REGIONAL REVIEW NOTIFICATION

ARC REVIEW CODE: R1809241

Name of Proposal: The Exchange at Gwinnett (DRI 2834)

THE EXCHANGE AT GWINNETT DRI 2834
Gwinnett County
ARC Natural Resources Group Comments
September 20, 2018

SP-37a

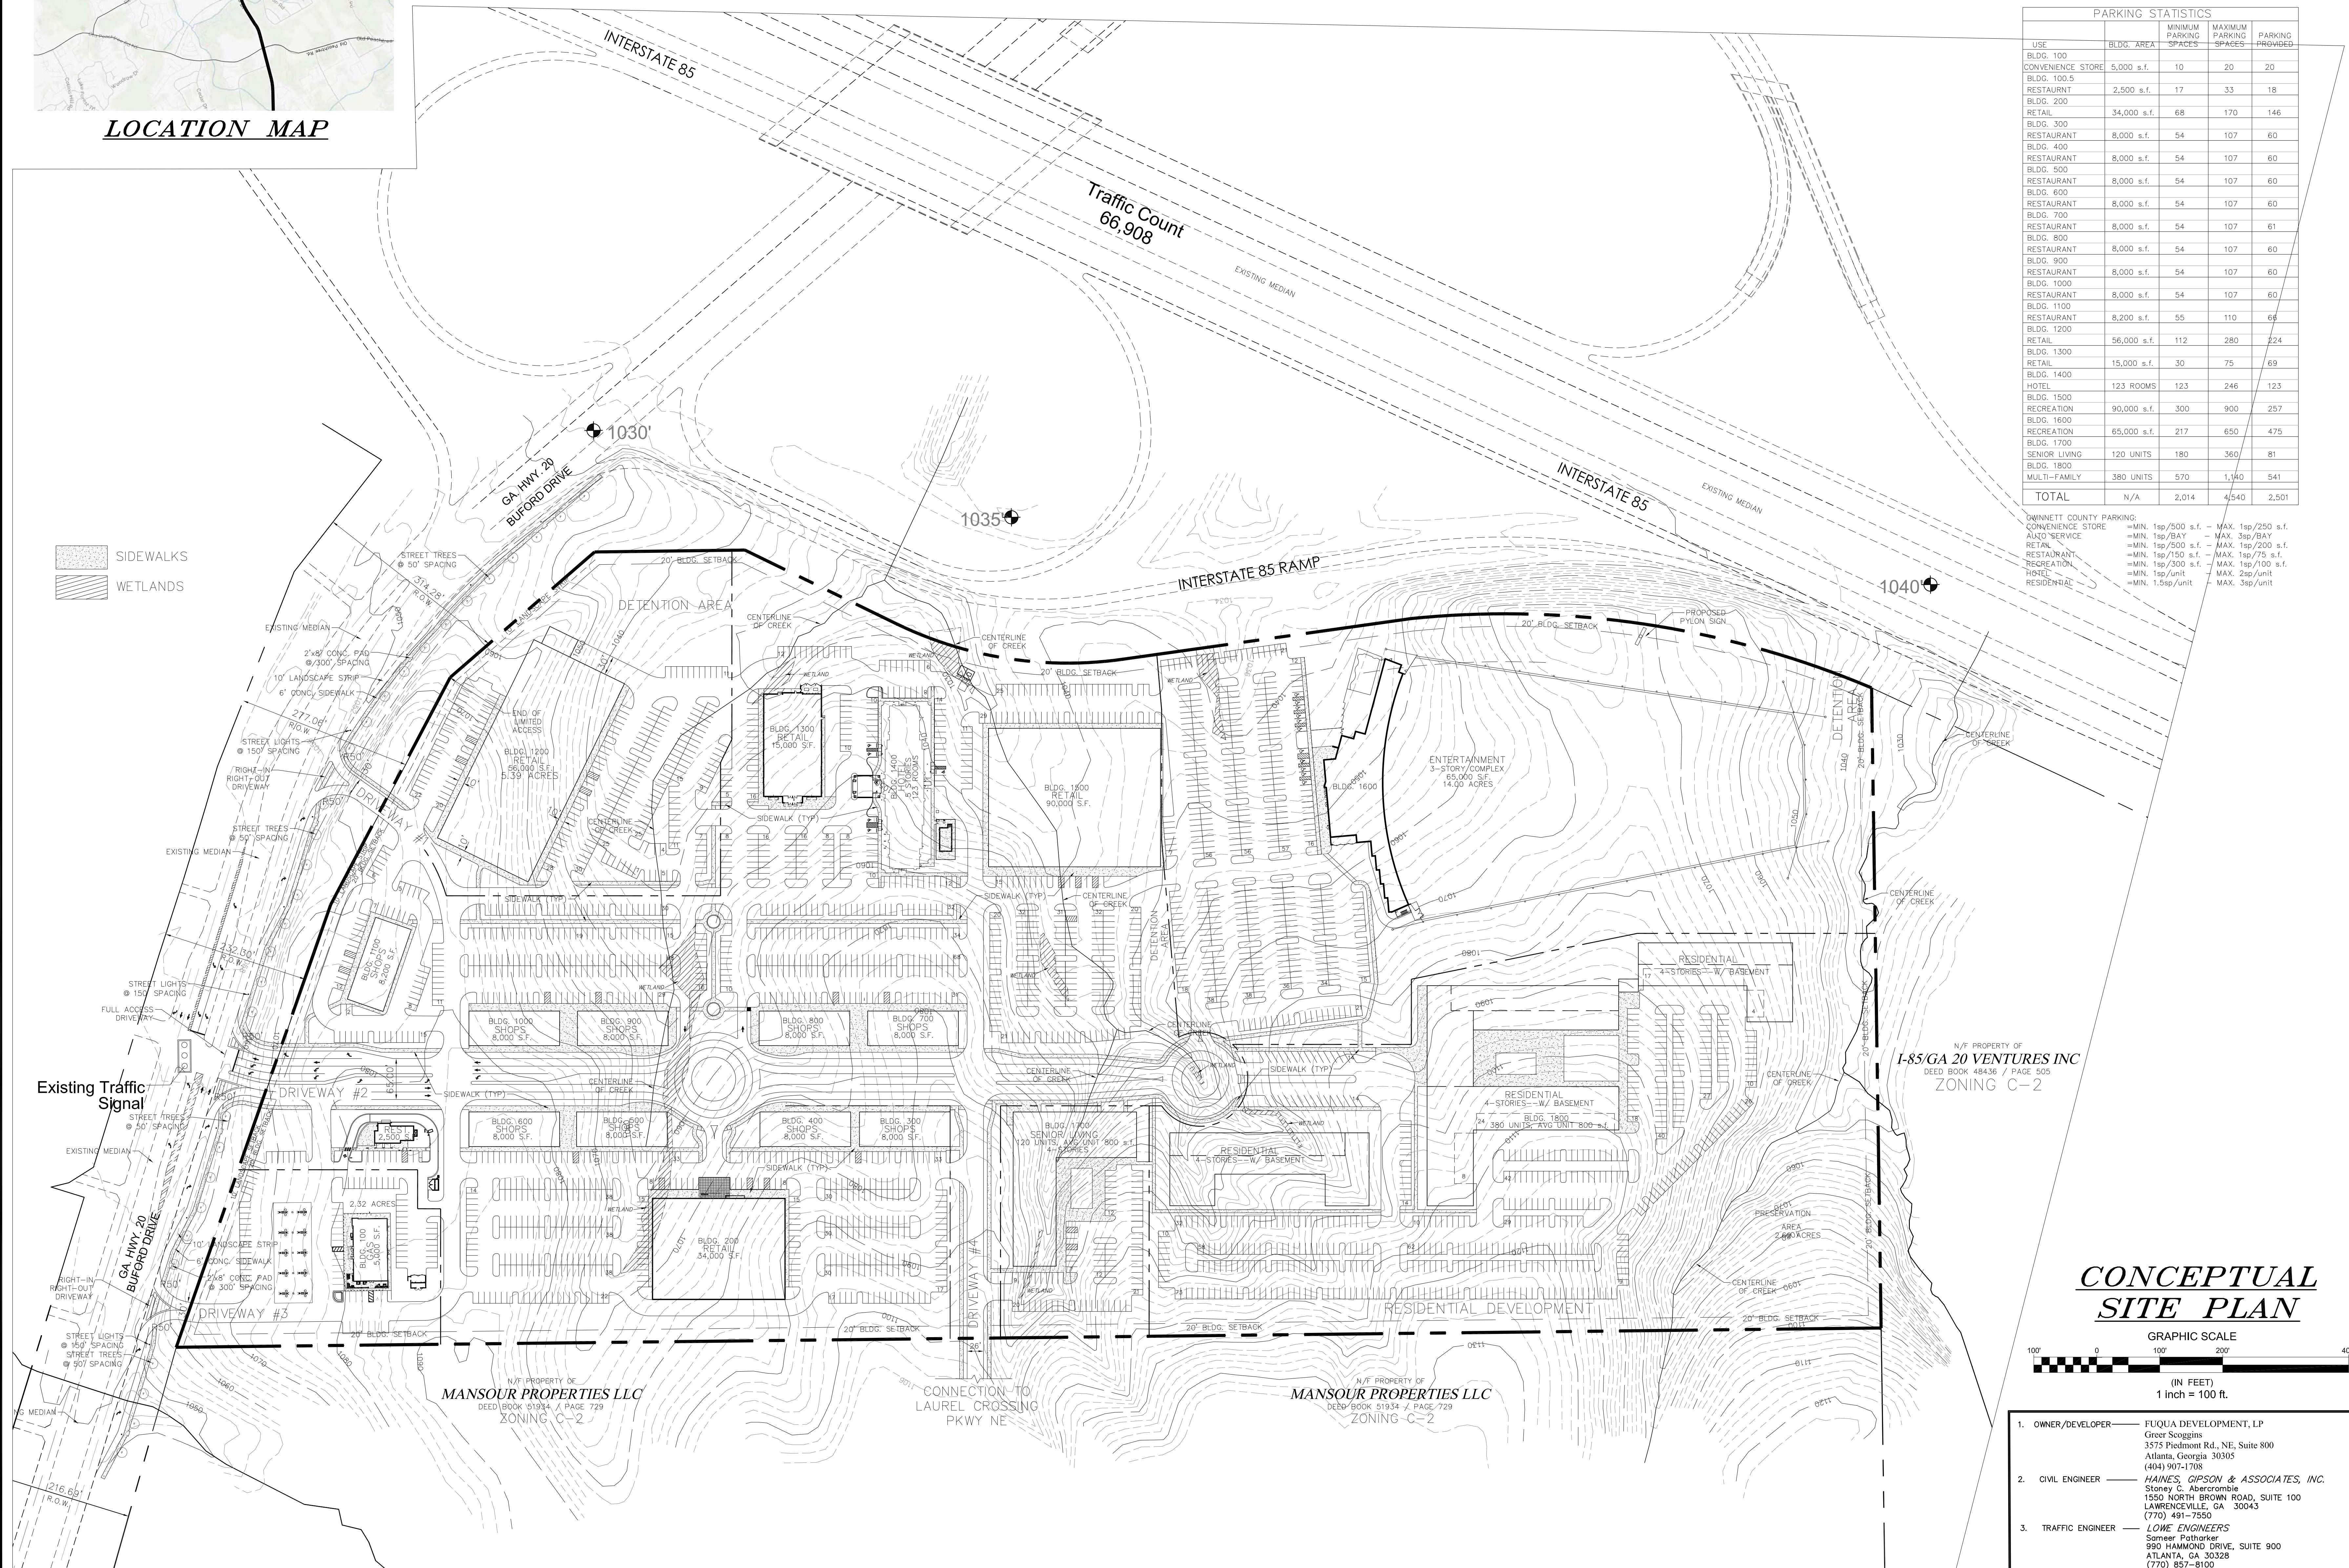
Both the submitted site plan and the USGS coverage for the project area show a tributary of Ivy Creek crossing the eastern side of the project property. A second tributary to Ivy Creek is shown on the site plan just to the south west of the project property. Ivy Creek is a tributary of Suwanee Creek, which flows to the Chattahoochee River. No buffers are shown for either stream. All streams on the property, including unmapped streams, are subject to the requirements of the Gwinnett County Stream Buffer, which include a 50-foot stream buffer and additional 25-foot impervious setback on most streams. All mapped or unmapped waters of the state on the property, including all streams, are also subject to the State 25-foot Sediment and Erosion Control buffer. All required buffers on the property should be shown on the site plan. Any development activity within the County buffer or setback may require a variance from the County. Any activity in the State 25-foot Erosion and Sedimentation buffer may also require a variance.

The development proposes sidewalks internal to the site connecting pedestrians to uses within the development. Sidewalk are proposed on along Buford Drive.

The development proposes sidewalks internal to the site connecting pedestrians to uses within the development. Sidewalk are proposed on along Buford Drive. No bicycle facilities are proposed.
